2. Major Difference (from previous model)

3. Exhaust System

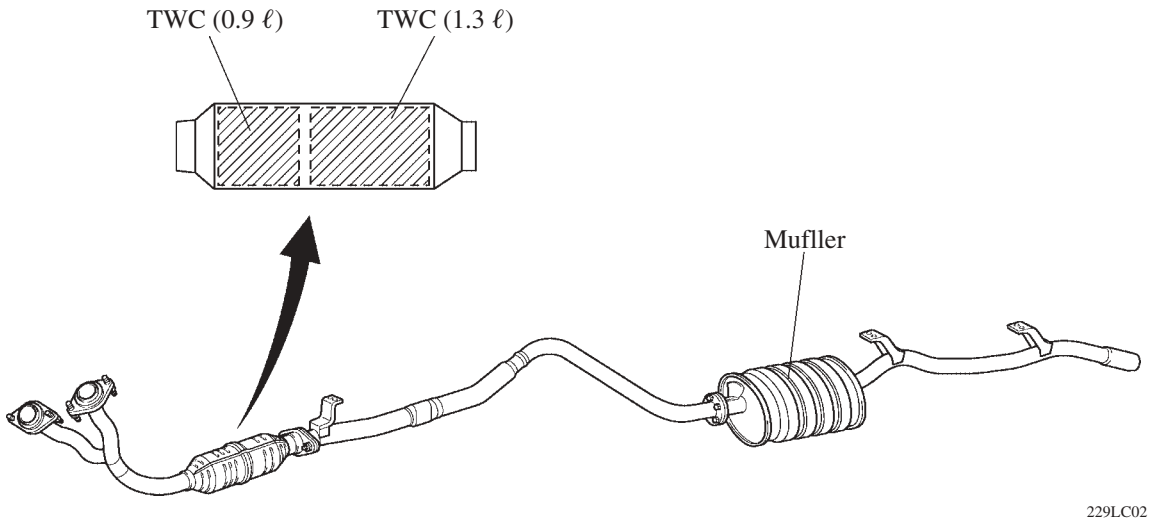
Two TWCs are used in order to comply with the European STEP II regulations.

Location	New*1			Previous*2		
	Cell Density	Volume	Material	Cell Density	Volume	Material
Front	62 cells/cm^2 (400 cells/in^2)	875 cm^3 (53.4 cu. in.)	Ceramic	62 cells/cm^2 (400 cells/in^2)	1291 cm^3 (78.8 cu. in.)	Ceramic
	62 cells/cm^2 (400 cells/in^2)	1291 cm^3 (78.8 cu. in.)	Ceramic
